Bloch Wind Farm Review

High Level Landscape and Visual Impact Review – Revised Scheme 24.04.2025

Bloch_LVIA_Review_24.043.2025

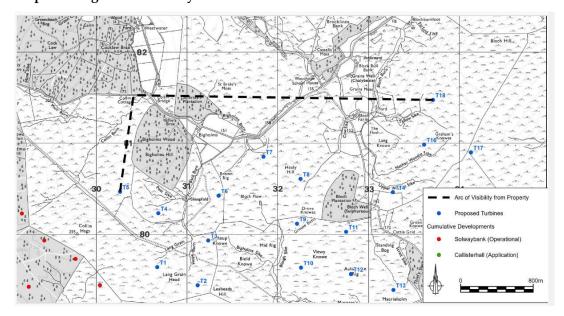
Turbines are already present within views from around this property. However, the proposed development would be noticeably closer, and proposed wind turbines would extend throughout the view from the primary aspect of the property.

Many of the proposed wind turbines would be partially screened behind local woodland. Of the five proposed wind turbines listed as most prominent within the view, T7 and T8 are sufficiently far away that they would not appear imposing or overbearing. Whilst T4 is located on higher ground, it is clearly screened behind Bigholms Wood, which provides a sense of separation between the property and the proposed wind turbines. As noted above, T5 would be most visible within the view and is the closest proposed wind turbine to the development. Whilst T5 would be clearly visible, it lies to the side of the property, outside of the main aspect and in an area where the existing wind turbines at Solwaybank Wind Farm can be clearly seen, albeit it is a much larger element within the view. Whilst the proposed wind turbines occupy a panoramic extent of the view from the primary aspect, many of the proposed wind turbines are screened and the wide extent of proposed wind turbines is not considered imposing or overbearing.

On balance, visual effects from this property would be insufficient to exceed the Residential Visual Amenity threshold and this would remain unchanged based on the Revised Scheme.

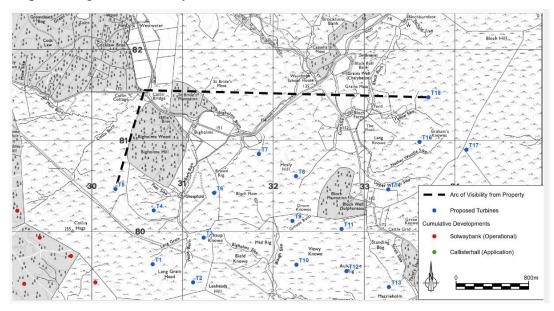
Most of the proposed wind turbines would be partially screened behind woodland. All three proposed wind turbines listed as most prominent within the view (T4, T5 and T6) would be screened behind Bigholms Wood, which would provide a sense of separation between the property and the proposed wind turbines.

T7 and T8 would appear sufficiently far away that they would not appear imposing or overbearing.

T5 is the closest proposed wind turbine to P3. Whilst T5 would be clearly visible, it lies to the side of the property, outside of the main aspect and in an area where the existing wind turbines at Solwaybank Wind Farm can be clearly seen, albeit it is a much larger element within the view.

To conclude whilst the proposed wind turbines occupy a wide extent of the view from the primary aspect, many of the proposed wind turbines are screened and the wide extent of proposed wind turbines is not considered imposing or overbearing.

On balance, visual effects from this property would not be sufficient to exceed the Residential Visual Amenity threshold and this would remain unchanged based on the Revised Scheme.

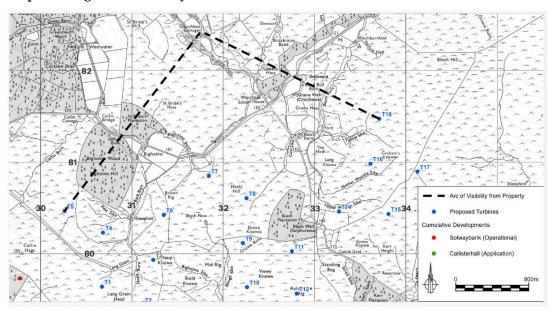
The properties already experiences turbines within views. However, the proposed development would be closer, and proposed wind turbines would extend the view of turbines from the primary aspect of the properties.

Several proposed wind turbines would be partially screened behind woodland with blade tips only visible for remaining turbines.

The closest turbine would be T7 though at nearly 1.55 km, with T8 and T18 set slightly further back. All three turbines would appear sufficiently far away that they would not appear imposing or overbearing.

Given the separation of the properties from the proposed development and intervening vegetation it is considered that the effects would not be so imposing as to be considered overbearing and therefore would not exceed the Residential Visual Amenity threshold based on the Revised Scheme.

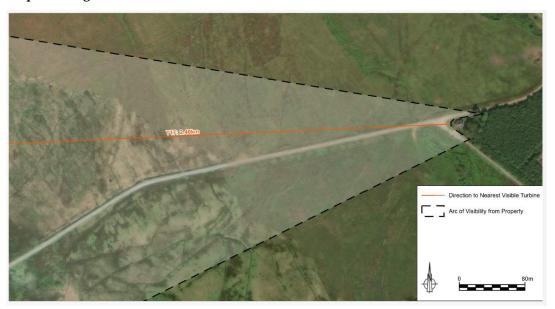
At night proposed wind turbine lighting would be visible.

The magnitude of change would remain unchanged at **Medium** resulting in a significant effect of **Major-Moderate** and **Adverse.** Whilst the removal of T19 – T21 and the height reduction of T16 - T18 from P27 would reduce the geographical extent of the proposed development, existing turbines are not present in the baseline view and therefore the change is insufficient to alter the magnitude of change from one level to another.

There are no turbines present within views from around this property. Turbines would likely be partially visible behind landform and views appreciated to the rear of the property and garden.

On balance, visual effects from this property would not be sufficient to exceed the Residential Visual Amenity threshold and this would remain unchanged based on the Revised Scheme.

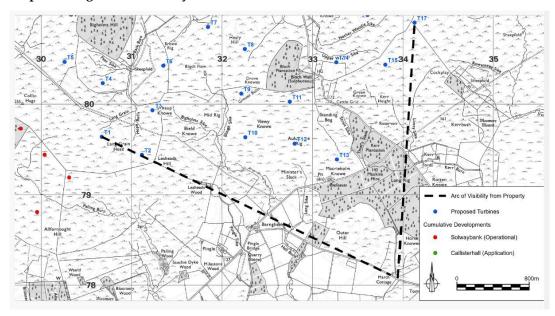
The closest turbine is T13 which would be 1.42km from the property, followed by T12, T11 and T10. Long Rig conifer plantation (assumed unfelled to the west) in the foreground would likely provide some screening of the lower sections of the turbines and this would relate to T7, T8, T11, T12. Only blade tips of T3, T4, T5 and T6 would be discernible. It should be noted that Outer Hill appears to include new forestry planting, however this is not yet at a height to provide sufficient screening.

The magnitude of change based on the Submitted RVAA would be **Medium** and this would remain unchanged alongside the significance of effect noted as **Major-Moderate** and **Adverse.** The removal of T19 – T21 and the height reduction of T16-T18 would be insufficient to alter the view . The turbines which are either removed or reduced in height would be distant in this view, while the retained turbines in the foreground would continue to foreshorten the view. The geographical extent of the proposed development would reduce slightly but this would be insufficient to tip from one criteria of magnitude of change to another.

From outside the property half of the proposed wind turbines would likely be at least partly screened by the intervening trees and buildings or landform, which will prevent the proposed development from feeling imposing or overbearing.

T13, T12, T11 and T10 would appear the closest turbines in the view though appear sufficiently far away that they would not appear imposing or overbearing. The proposed development would be seen in context with Solwaybank Wind Farm with T1 and T2 appearing to "link" with the existing wind farm.

To conclude whilst the proposed wind turbines would occupy a wide extent of the view, there is sufficient distance and partially screening by trees and buildings in the foreground to ensure that they would appear separate from the property. The proposed wind turbines would not be considered imposing or overbearing.

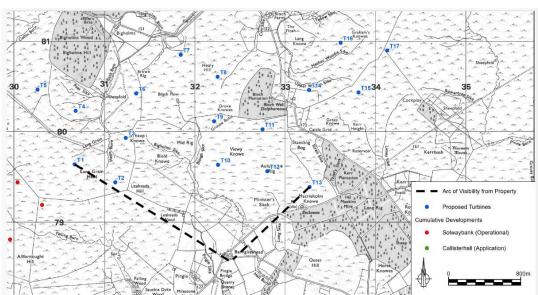
The magnitude of change based on the Submitted RVAA was **Medium** and this would remain unchanged alongside the significance of effect noted as **Major-Moderate** and **Adverse.** The removal of T19 – T21 and the height reduction of T16 - T18 would be insufficient to alter the view. The turbines which are either removed or reduced in height would be distant in this view, while the retained turbines in the foreground would continue to foreshorten the view. Visual clustering would reduce through the loss of turbines, slightly improving the balance of the overall scheme, and the reduction in heights of T16 - T18 would increase the perceived distance between the turbines and the property. The extent of the proposed development however in the view would remain unchanged.

From outside the property most of the proposed wind turbines would be at least partly screened by the intervening trees and buildings, which would prevent the proposed development from feeling imposing or overbearing.

T10, T12 and T13 would appear the closest turbines in the view and would be seen in context with Solwaybank Wind Farm albeit appearing a larger element of the view, partially screened by trees and buildings in the foreground and viewed from the rear of the property and associated curtilage.

T8, T9 and T11 would appear sufficiently far away that they would not appear imposing or overbearing.

FIGURE 10067_P36_OPT DATE 05/03/2025 Sheet 1 of 2

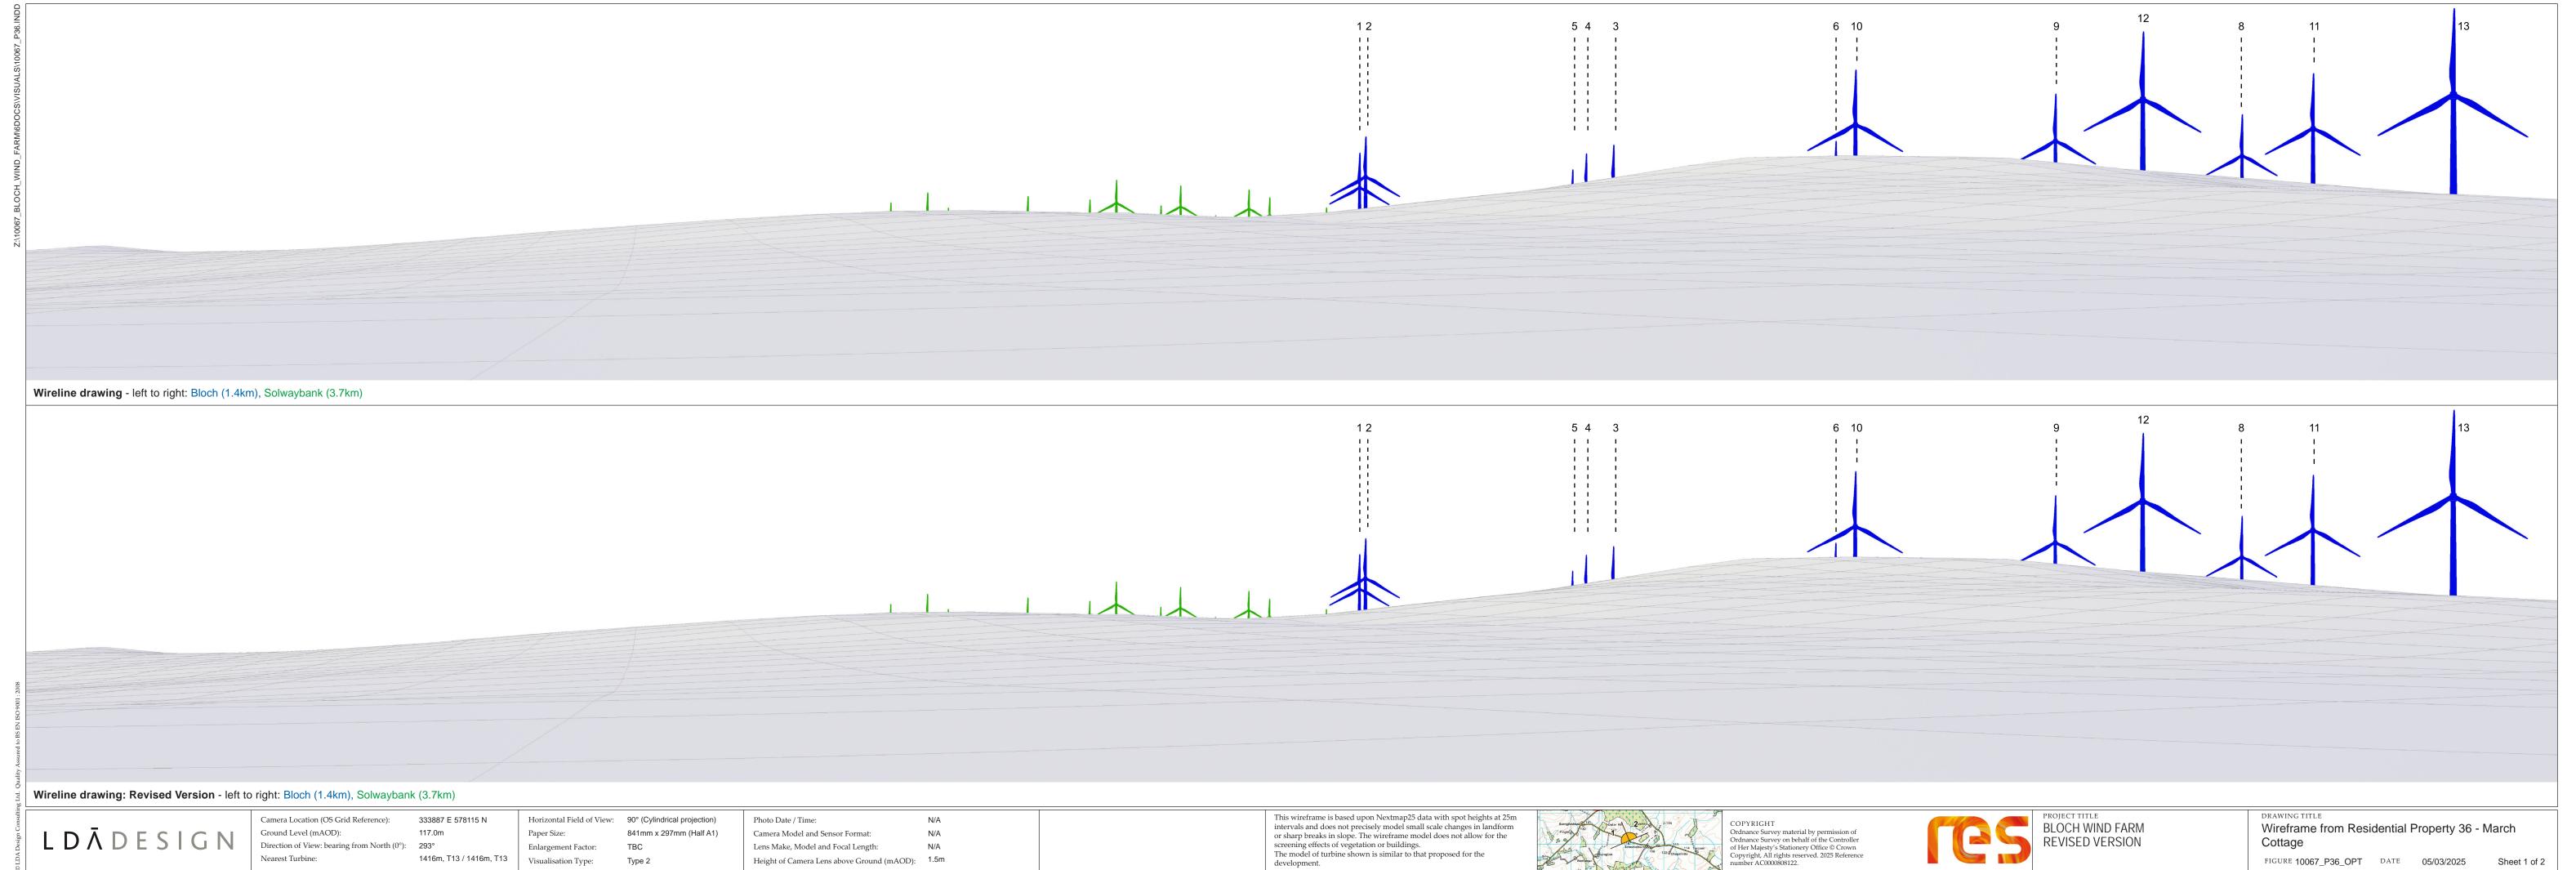
Wireline drawing - left to right: Bloch (1.4km), Solwaybank (3.7km) Wireline drawing: Revised Version - left to right: Bloch (1.4km), Solwaybank (3.7km) This wireframe is based upon Nextmap25 data with spot heights at 25m intervals and does not precisely model small scale changes in landform or sharp breaks in slope. The wireframe model does not allow for the screening effects of vegetation or buildings.
